The Regular Meeting of the **Brian Head Planning Commission**

- 1. PUBLIC HEARING: Aspen Meadows Christmas Tree Neighborhood and Nordic Center Preliminary Plat** - Greg Sant, Planning and Building Administrator.
- 2. ADMINISTRATIVE ACTION: Aspen Meadows Christmas Tree Neighborhood and Nordic Center Preliminary Plat** - Greg Sant, Planning and Building Administrator.
- 3. DISCUSSION ON FUTURE LMC ITEMS TO BE PUT ON AGENDA: Parking and Sign ordinances and Potential Transitional Residential Zoning Locations.**

AUTHOR: Greg Sant
DEPARTMENT: Planning and Building
DATE: February 3, 2026
TYPE OF ITEM: Administrative Action

ALPINE CHRISTMAS TREE AREA - PHASE 1

PRELIMINARY PLAT

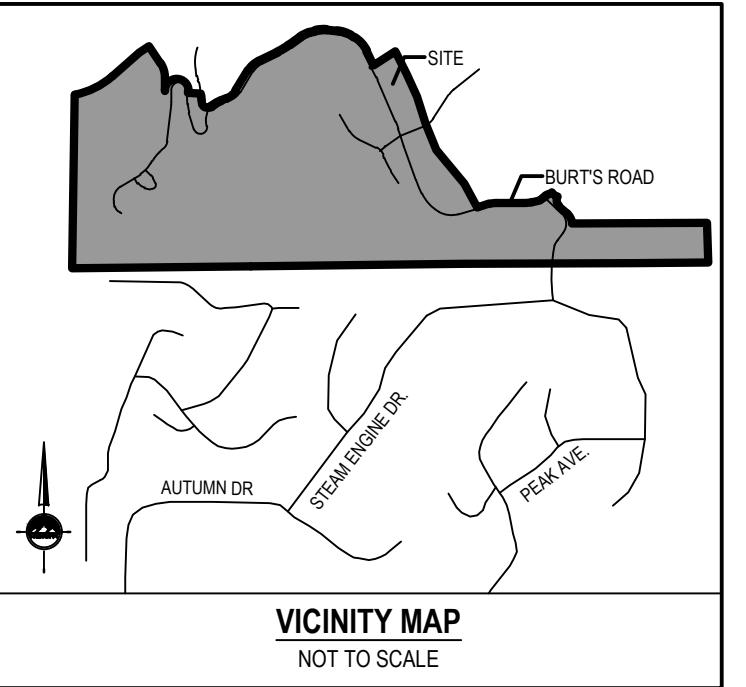
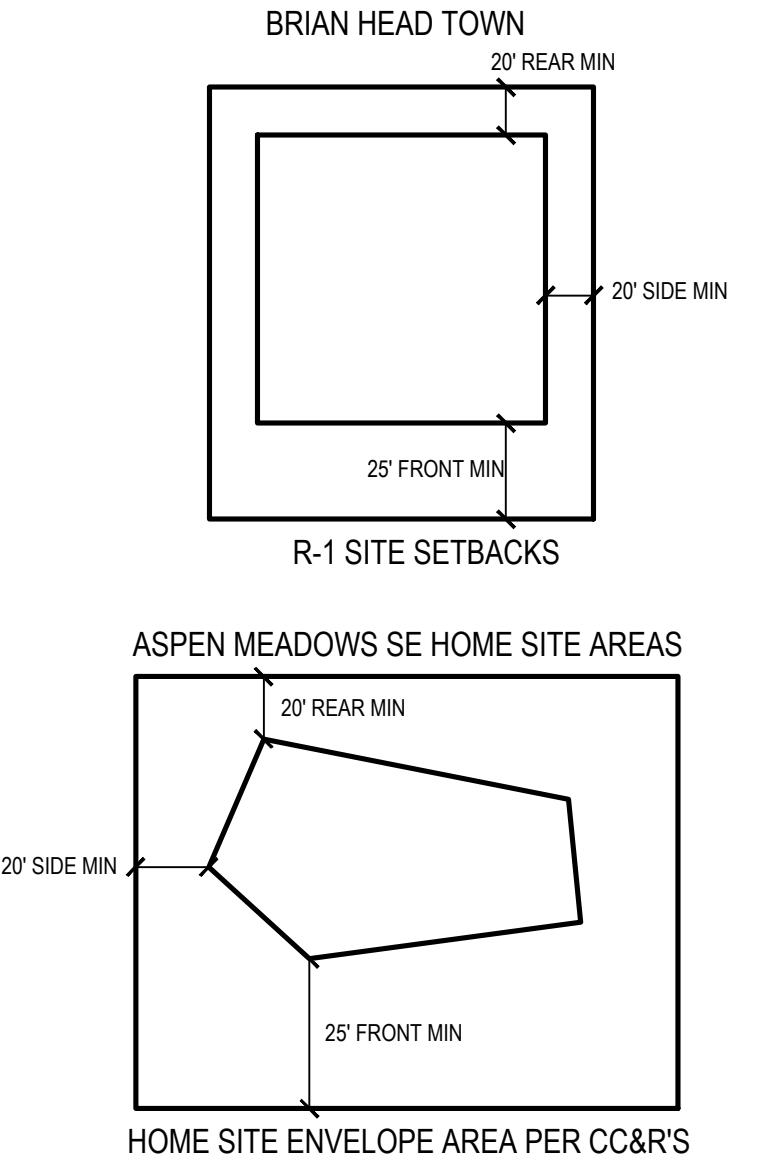
- (1) The lots on the Preliminary Plat do not show lot line measurements therefore, it is hard to determine if they meet the required frontage length.

- (2) There are not two (2) points of access or egress called out as required by 9-12-9 A(4). Once Burts Road to Nowhere is installed to meet up with Aspen Meadows Dr. this issue will be resolved. Staff recommends including appropriate notes to call out this secondary access and ensure it is accessible to residents and visitors of the neighborhood as well as emergency response personnel.

- (3) The existing impact of the added traffic to HWY 143 and Steam Engine Dr. are not known without a Traffic Study. As indicated in 9-12-9 A(5), this is a study that may be requested by the Town if warranted. UDOT has asked the Town to require such traffic studies to ensure that any necessary improvements to Hwy 143 necessitated by increased traffic are required of the applicant.

- (4) Aspen Meadows Dr. is approximately one (1) mile in length and lacks the adequate number of turnarounds as required in 9-12-9 A(12.b). Again, once Burts Road to Nowhere is installed and meets up with Aspen Meadows Dr., this issue will be resolved.

- c. Public Services for the Preliminary Plat and Exhibits were reviewed by the Public Works Department, and they offer the following comments:
 - i. Water: Potential issue with the dead-end of the water line that extends to the commercial piece, however, in the long-term, once Aspen Meadows Dr. and the utilities are extended down to Burt's Road to Nowhere then this will be a short dead-end and would be acceptable. There will be some water pressure issues that will require PRV's, but as long as the developer follows Town Standards it will be acceptable.

- ii. Sewer: Using the E-One system mitigates potential issues. If it is designed according to manufacturers' specifications and construction drawings are reviewed and approved by the Public Works Department then it is acceptable.

- d. Public Safety has reviewed the Preliminary Plat and Exhibits and have offered the following comments: Fire Hydrants must be placed per Town Standards, Second Access/Egress needs to be addressed, and Turnarounds need to be addressed.

1. The Preliminary Plat needs to be revised to show the Lot Dimensions.
2. There needs to be a resolution regarding the second access that is required by the LMC. This could be a temporary access through other property owned by the Applicant, requiring Burt's Road to Nowhere to be developed within a certain time, etc. Along with this discussion, the need for turnarounds needs to be addressed.
3. There needs to be a time by which a Traffic Study would be completed in order to address questions that might arise from UDOT and citizens along Steam Engine Dr.
4. A Zone Change application needs to be submitted by the Applicant, and the Zone Change must be completed before the Preliminary Plat would be approved.
